Access Compliance Report

Public Rights-of-Way

(Curb Ramps)

Intersection ID: N/A	Main Street: COVINGTON COMMONS DR	Cross Street: REECE VALLEY CT	Location: NE
ADA ID: CAD6CA044FC2	Ramp Type: PerpDiag	Initial Pass/Fail: Fail	Overall Compliance: No
Codes/Mitigation Info/Possible Solution		Field Measurements/Component Compliance	
Severity Score: 46.25

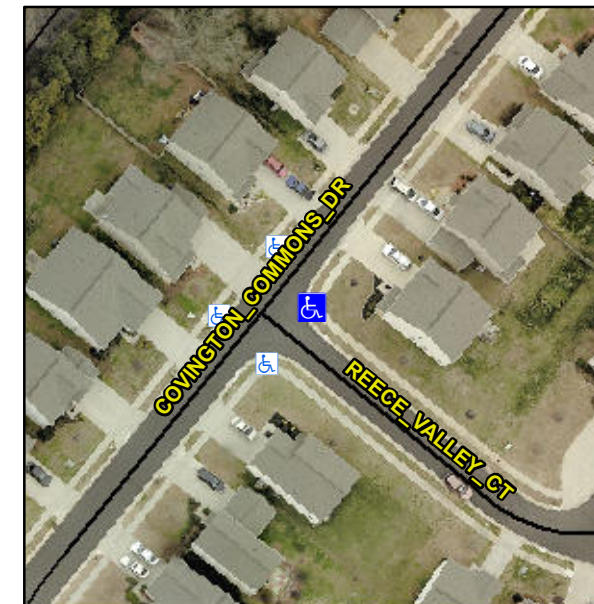
Not Found, R304.5.1, R304.2.2, R304.5.3

Compliance	Description	Data	Compliance	Description	Data
N/A	Ramp Length (in)	48.0	No	Ramp Slope (%)	12.1
No	Ramp Width (in)	46.0	No	Ramp XSlope (%)	5.4
N/A	Flare Type LT	N/A	N/A	Flare Type RT	N/A
N/A	Flare Slope LT (%)	N/A	N/A	Flare Slope RT (%)	N/A
N/A	Flare Traversable LT?	N/A	N/A	Flare Traversable RT?	N/A
N/A	Landing Length (in)	N/A	N/A	DWS Provided?	N/A
N/A	Landing Width (in)	N/A	N/A	DWS Contrast?	N/A
N/A	Landing Slope (%)	N/A	N/A	DWS Length (in)	N/A
N/A	Landing X Slope (%)	N/A	N/A	DWS Full Width?	N/A
N/A	Landing Curb? (Y/N)	N/A	N/A	DWS Offset (in)	N/A
N/A	Shared Landing?	N/A			
N/A	Gutter Ponding?	N/A	N/A	Gutter Slope (%)	N/A
N/A	Gutter Lip Ht (in)	1.0	N/A	Gutter X Slope (%)	N/A
N/A	Painted X Walk1?	No	N/A	Painted X Walk2?	No
	X Walk 1 Direction	To NW		X Walk 2 Direction	To SW
N/A	X Walk 1 Width (in)	N/A	N/A	X Walk 2 Width (in)	N/A
	X Walk 1 Slope (%)	3.1		X Walk 2 Slope (%)	0.1
	X Walk 1 X Slope (%)	1.8		X Walk 2 X Slope (%)	3.7

Remove & Replace Curb Ramp With Two New Directional Ramps or Equivalent.
